West Santa Ana Branch Transit Corridor

Final EIS/EIR Appendix D: Responses to Comments Received on
the Draft EIS/EIR

**Final EIS/EIR Appendix D:
Responses to Comments
Received on the Draft
EIS/EIR
Part 1**

March 2024

1. I-105 Station

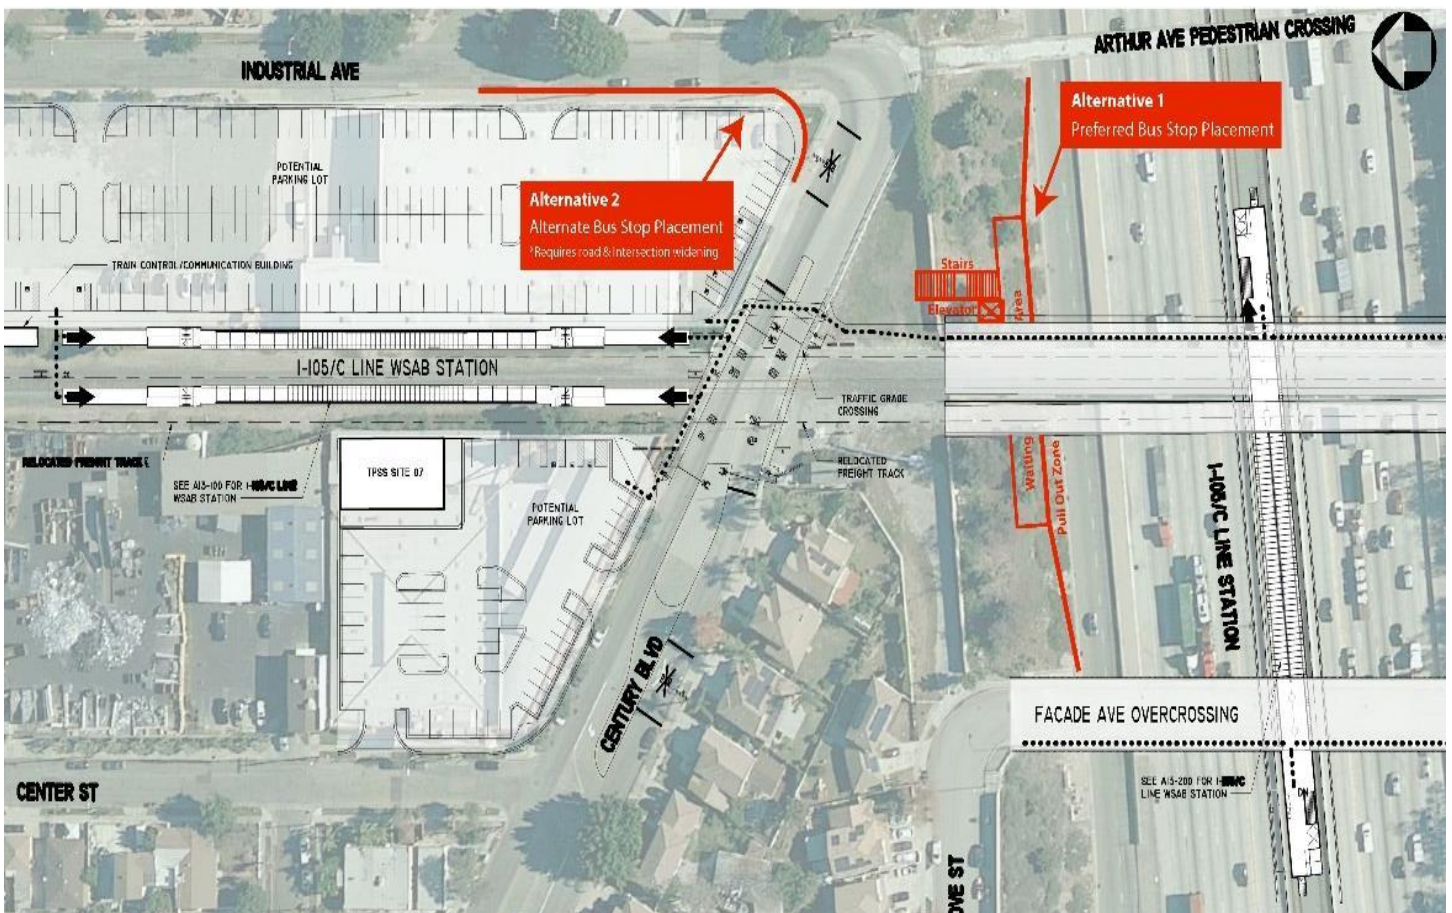
LBT proposes extending Lines 21 and 23 to the I-105 Station. Line 21 operates from Downtown Long Beach to Rosecrans Avenue mostly along Cherry and Garfield Avenues, and Line 23 follows a similar routing to Line 21 except for serving a short stretch of Paramount Blvd in the city of Paramount. The routes will be extended to serve this station via a loop from Garfield/Paramount via S/N Somerset Ranch Road, Garfield Avenue/Paramount Blvd, N/S Somerset Ranch Road.

Option 1 - LBT's existing Routes 21, 23 and 71 will serve on-street stops at this location. A turnaround loop will be required in the parking lot to orient buses in the correct direction. Buses will layover on the westbound direction of Rosecrans Ave, after the existing bus stop.

Option 2 - Relocate the end of line/layover to the corner of Paramount and Rosecrans. Routes 21 & 23 layover on Rosecrans at Paramount NW is fine as shown in the site plan. However, Paramount at Rosecrans SW requires constructing a pull-out bus bay to allow for layover on Paramount (by Dentist sign). Alternatively, the layover could occur before the intersection on Rosecrans by removing a travel lane and peak hour parking restrictions.

3. Bellflower Station

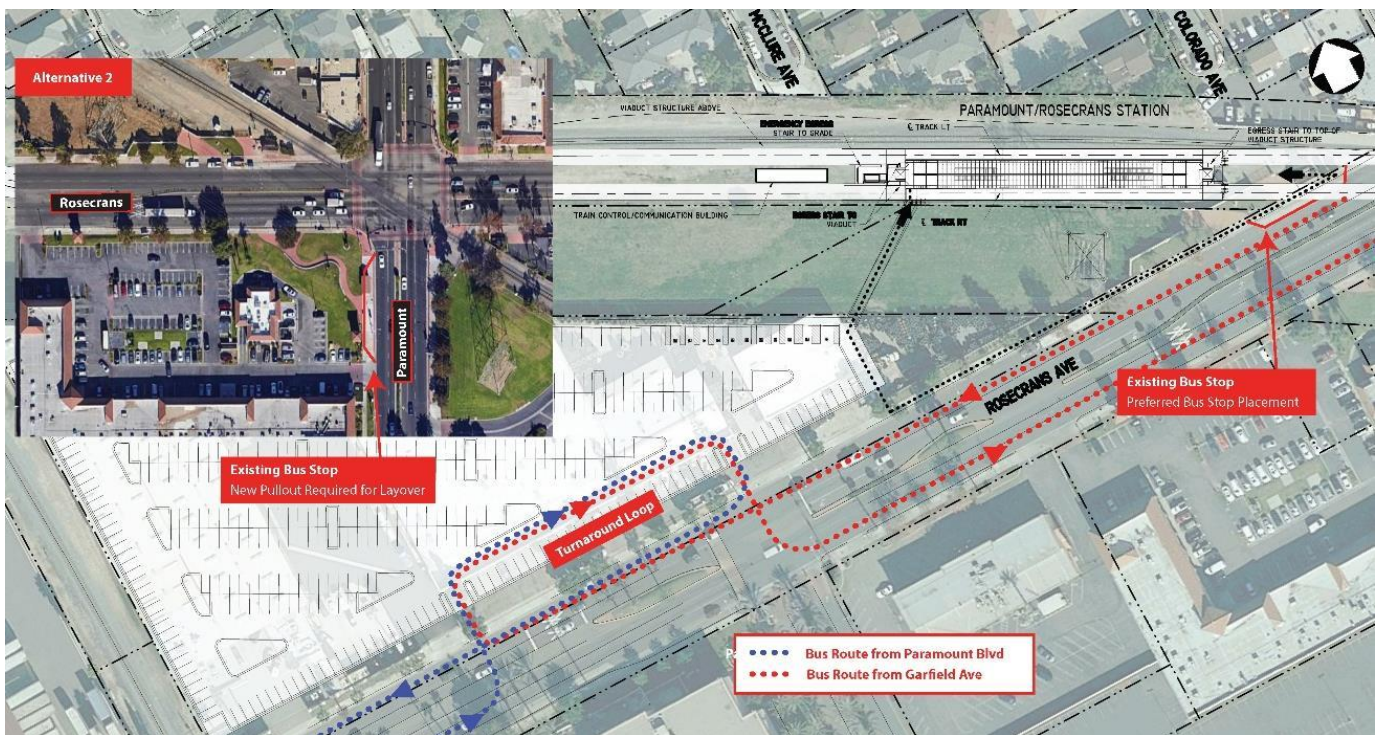
To allow for buses to end and layover at this station, LBT would like to request the following:

- a. One bus stop in each direction on Bellflower Blvd directly in front of the station. Both bus stops should allow space for two buses to layover/board/disembark passengers simultaneously. Both of these bus stops should be located sufficiently south of the turnaround described below, to allow for buses serving both stops to utilize the turnaround.
- b. Space for a 40' transit coach to turn around in the park and ride lot adjacent to the station. This turn around should be accessible from both the north and the south to allow for buses to be oriented in the correct direction without utilizing residential streets. The entrance/exit to this turnaround from Bellflower Blvd should be traffic signal controlled. If space in the turnaround loop permits, a bus stop should be added to provide a safer boarding location for passengers.

4. Pioneer Station

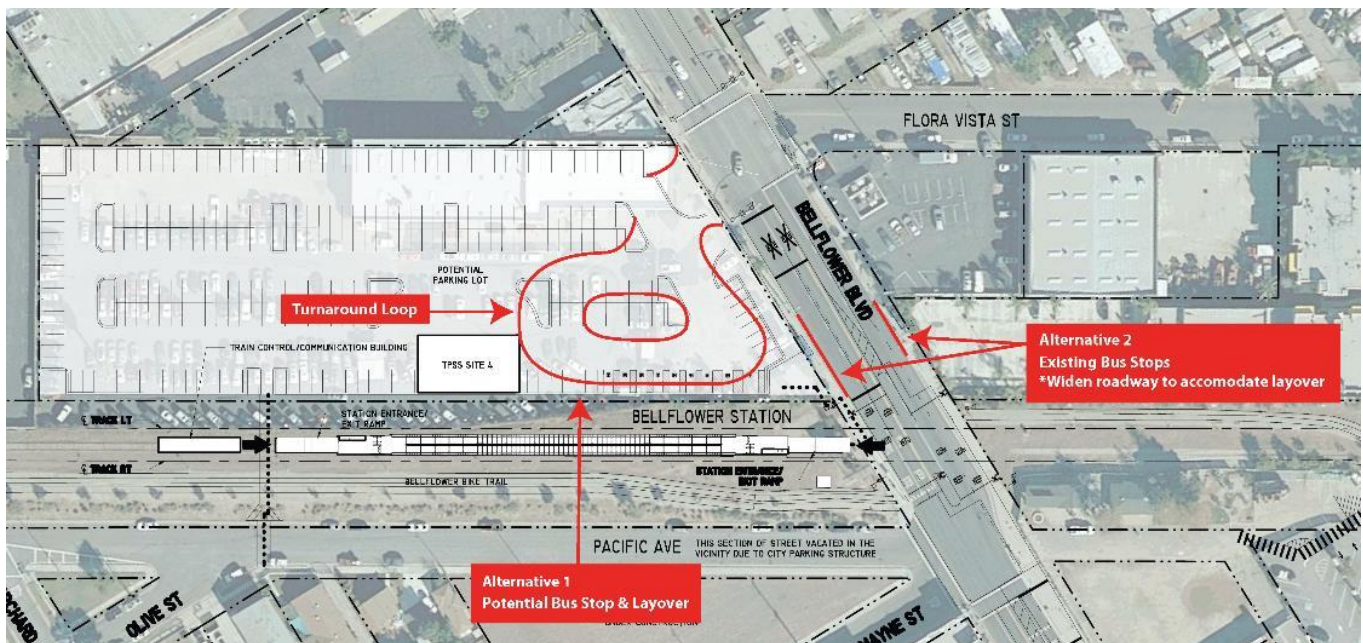
The following routes are proposed to be modified to serve Pioneer Station:

- a. Current Metro / future LBT Route 130 Artesia Blvd will be extended from Cerritos Center to Pioneer Station via 183rd, Pioneer to Pioneer Station. This route will need to layover at the Pioneer Station bus facility.
- b. LBT Route 192 South Street will be extended from Cerritos Center to Pioneer Station via South, Pioneer to Pioneer Station. This route will need to layover at the Pioneer Station bus facility.
- c. LBT Route 173 will loop through the Pioneer Station bus facility but will continue to layover at Norwalk Station.

Figure 8-4. Intersection Nos. 48 and 49 Lane Configuration with Mitigation Measures

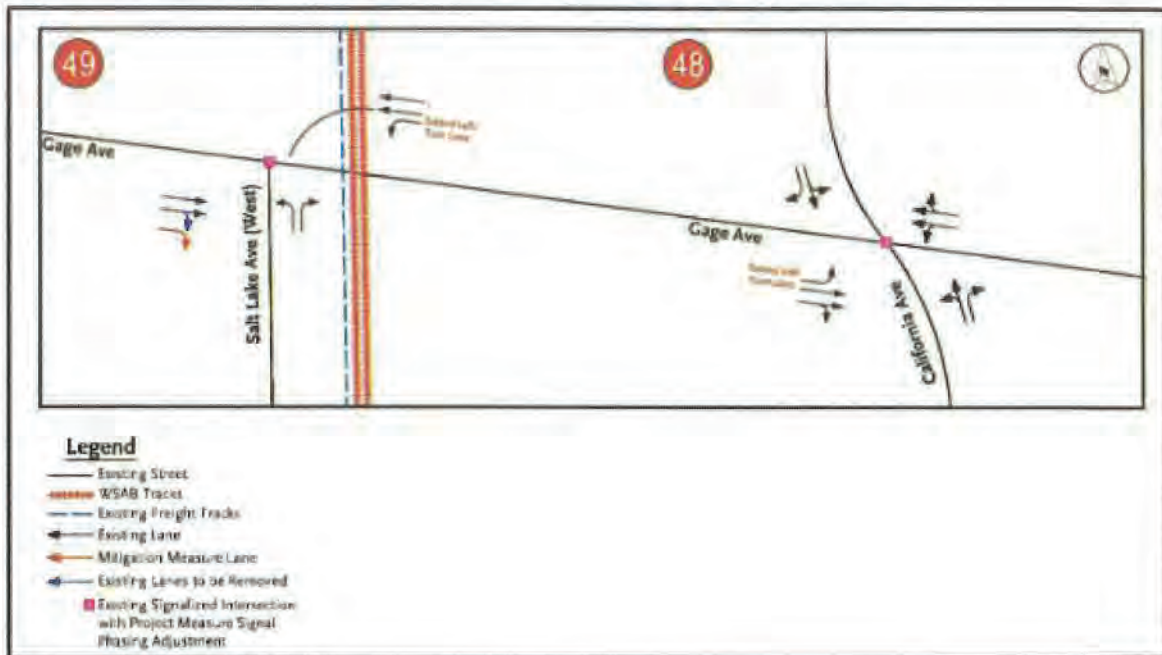
Revised mitigation measures were applied to these 2 intersections and resulted in Table 8.6. Mitigation Measures for Intersections Nos. 48 and 49 (Page 8-14) and Figure 8-4. Intersection Nos. 48 and 49 Lane Configuration with Mitigation Measures (Page 8-15).
